AMENDMENTS TO THE DRAWINGS:

REMARKS

Reconsideration in view of the foregoing amendments and the following remarks is respectfully requested. Moreover, the applicants have reviewed the Non-Final Office Action of June 2, 2006, and submit that this paper is responsive to all points raised therein.

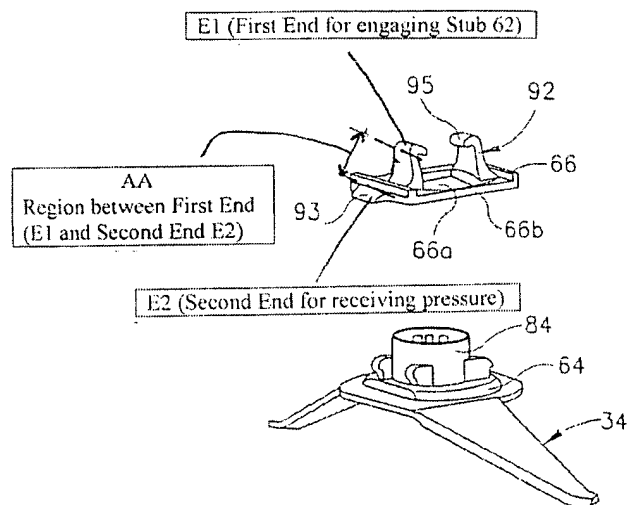
Please note that the previously amended “platforms” has been removed from claim 9 and replaced by “force receiving members.” It is respectfully asserted that in Figs. 5-7, element 93 is a “force receiving member”, and as such, is clearly shown in the drawings.

The “discontinuous with” recitation in claim 19 has been replaced with “separate from.” The requisite portion of the recitation, with reference to the drawings (element numbers added) reads, “said second portions 93 separate from and in communication with said first portions 95.” The “separation” in the claim language is based on elements 93 and 95 being at opposite ends of the flexible member 92, with the main body 94 located between elements 93 and 95.

DRAWING A
Claims 9, 12, 16 and 19

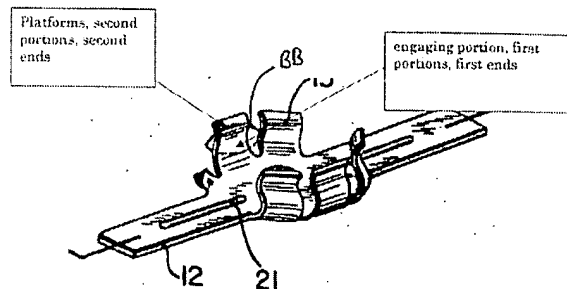
Independent claims 9 and 16 include recitations directed to a receiver formed by structures including a receiving portion and flexible members, with the flexible members including structures at one end for engaging the rotating member, and at the other or opposite end, for receiving pressure, for moving the engaging structure out of engagement with the rotating member. For example, as shown Drawing A (taken from the exploded view of Fig. 5 of the instant patent application) there is a receiving structure 84 with flexible members 92.

Independent claims 12 and 19 are similar to claims 9 and 16, in that they recite the two portions of the flexible members, with engaging structures at one end, and pressure receiving structures, at the other, or opposite, end. In claims 9, 12, 16 and 19, the structure of the flexible members that engages the rotating member, is different and separate from the structure that receives the pressure (for moving the rotational member engaging structure). For example, as shown in Drawing A, the flexible members 92 include structure 95 for engaging the rotating member at a first end (E1), this structure 95 at the first end (E1) being different and separate from the structure for receiving pressure 93 at the second end (E2), the structures 93, 95 separated from each other by the region AA.

FIG.6

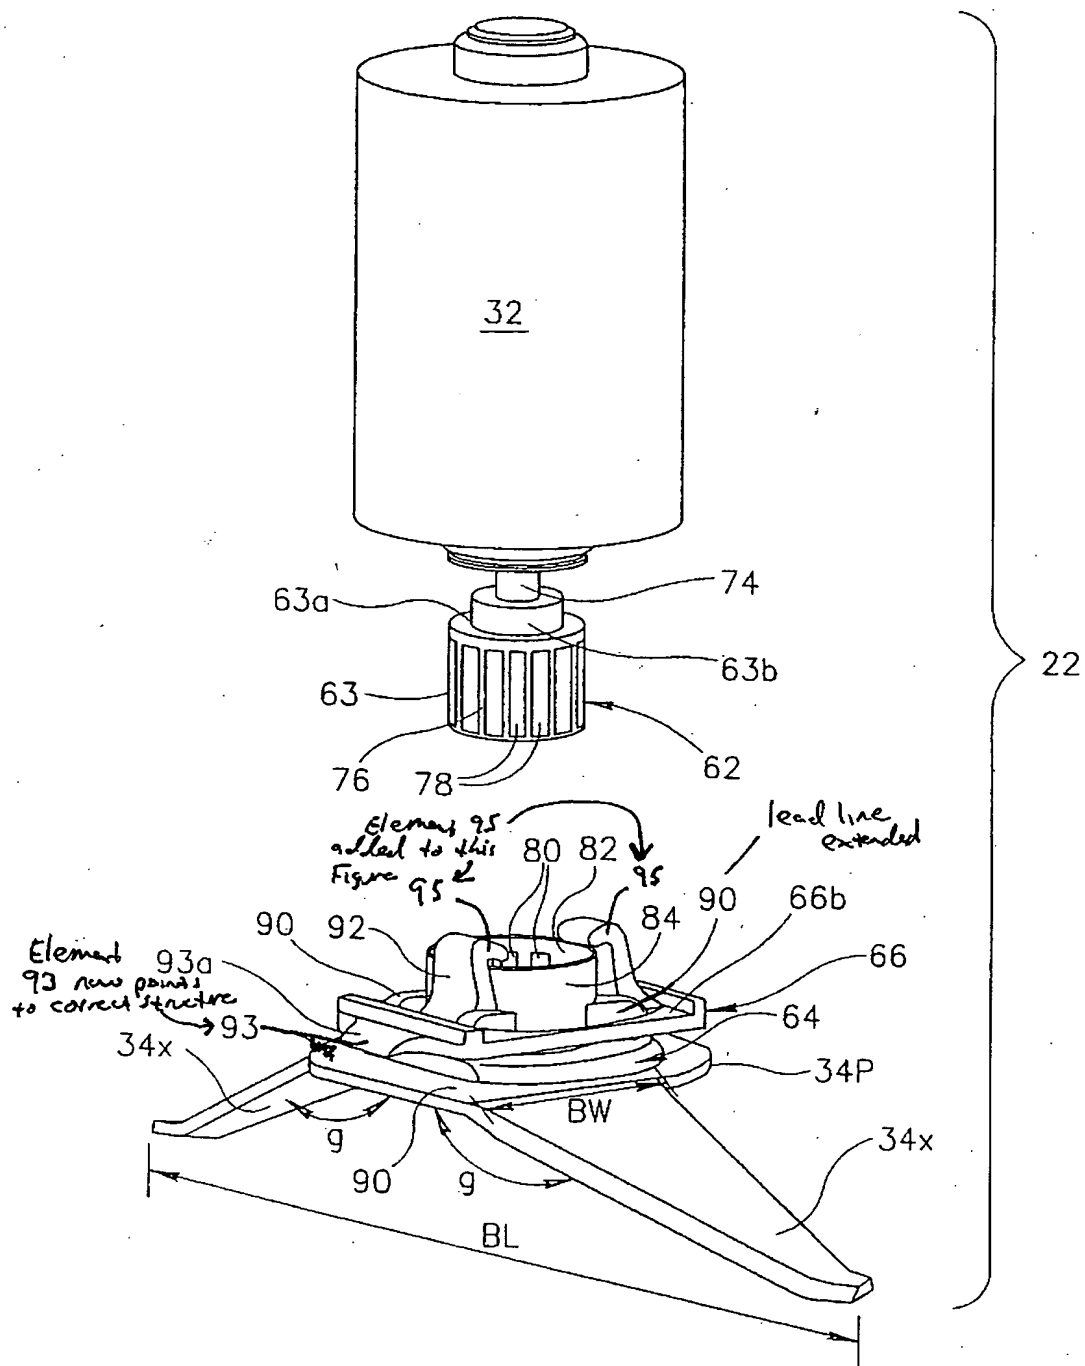
In Fig. 6, elements 90 and 93 have been provided with a corrected lead line, to point to the correct structure. Element 95 has been added.

FIG.7

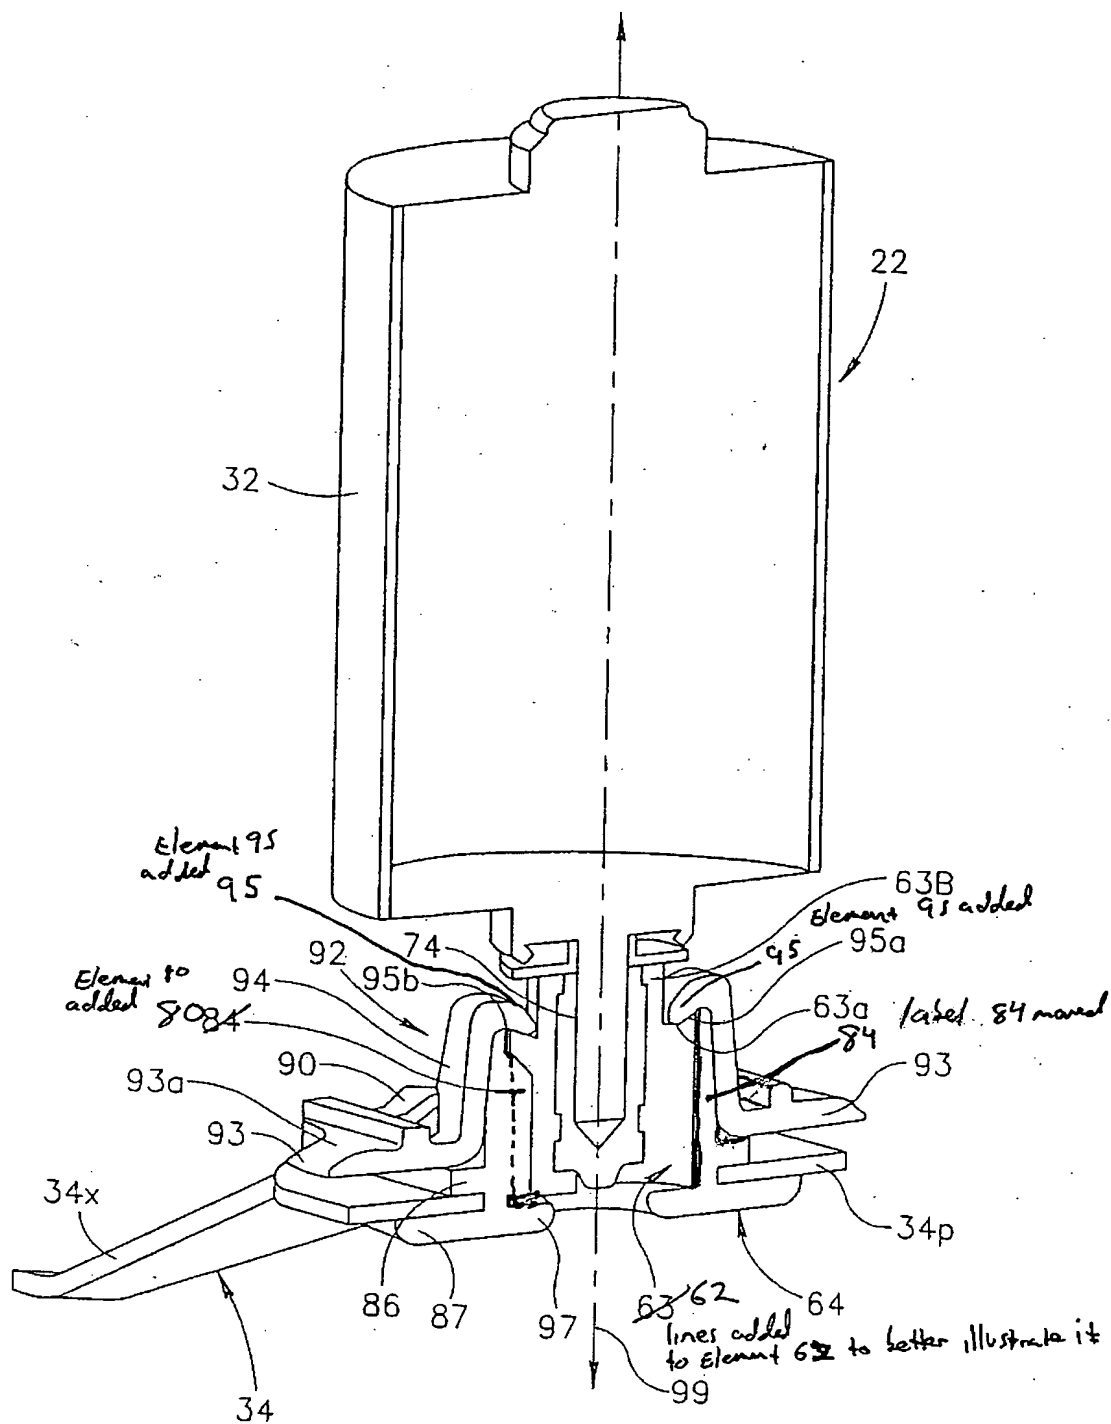
In Fig. 7, element 63 has been changed to 62 to reflect the stub accurately, and the stub 62 has been more accurately depicted. Element 80 has been added. The “84” has been moved with a lead line added to show element 84. Element 95 has been added.
